ALTO PRODUCTS CORP.

New Product Release

Direct Clutch PowerPack - TH200 – TH200C – TH2004R
Alto Kit # 043757

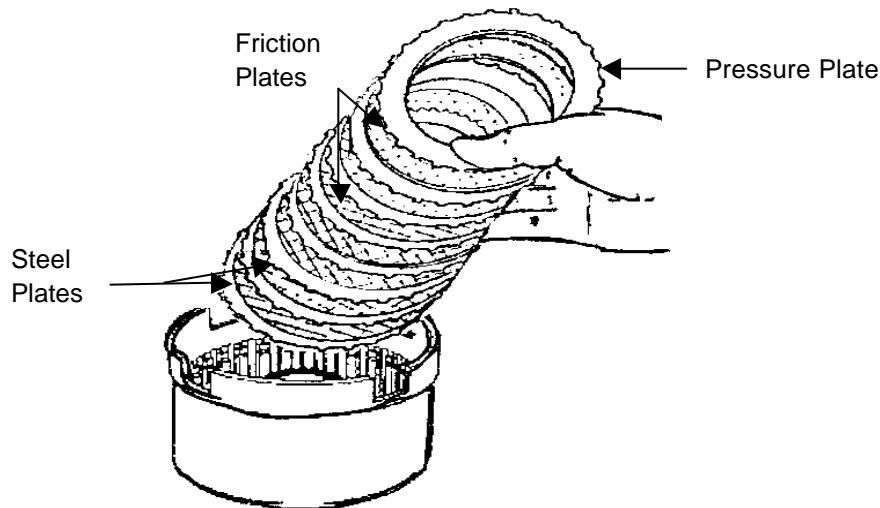
Problem: The direct clutch has sufficient capacity for the normal consumer vehicle. However, if higher horsepower and more torque demands are introduced, the direct clutch will fail.

Solution: Alto Products Corp. has designed a new Powerpack for the direct clutch. You can replace the normal 5 friction and 5 steel plate setup with 7 friction and 7 steel plates. This added capacity will allow for the addition of higher engine horsepower, and will also handle the additional torque demands.

Installation: Stack up is the same as OE, starting with a steel plate and then alternately installing friction and steel plates ending with the pressure plate. Clutch pack clearance should .008" to .010" per lined plate. Check clearance using a feeler gauge between the snap ring and the bottom of the top pressure plate.
